1.0 DECLARATION

1.1 Site Name and Location

This Record of Decision (ROD) presents the selected final remedy for Operable Unit (OU) 4 Site 1 – Former Drum Marshalling Area, located at Naval Weapons Industrial Reserve Plant (NWIRP), Bethpage, New York (Figure 1-1). This ROD is a supplement to Site 1 activities identified in the 1995 OU 1 ROD. Sites 2 and 3 activities are complete and those remedies remain unchanged from the OU 1 ROD dated May 1995.

Re: Naval Weapons Industrial Reserve Plant Site
Operable Unit 4 Site 1 - Former Drum Marshalling Area
NYSDEC Site ID No.130003B

Figure 2-6 Selected Soil Vapor Alternative (SV-3)

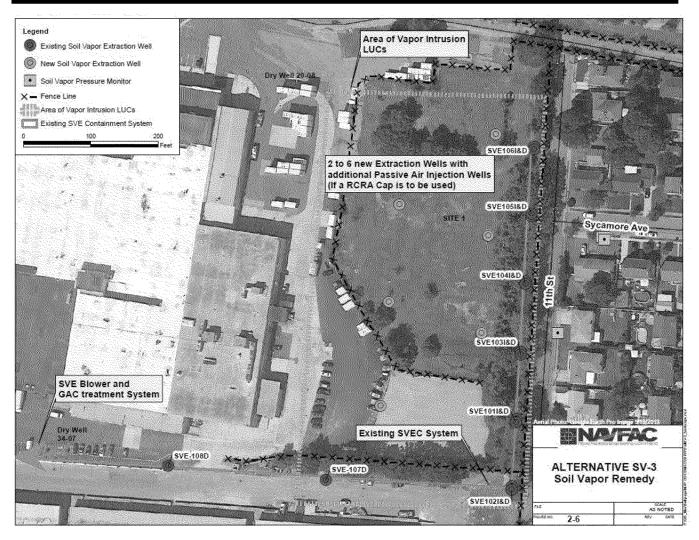
<u>Comment 3:</u> The soil vapor alternative/component must continue to be protective of human health and, therefore, any modifications to the soil vapor extraction system operation, maintenance and monitoring needs to be reviewed by the NYSDEC and NYSDOH. Please assure that the ROD notes this requirement.

<u>Response:</u> The plan for construction, operation, maintenance, and monitoring of the existing and new soil vapor extraction system will be distributed to NYSDEC and NYSDOH for review and comment.
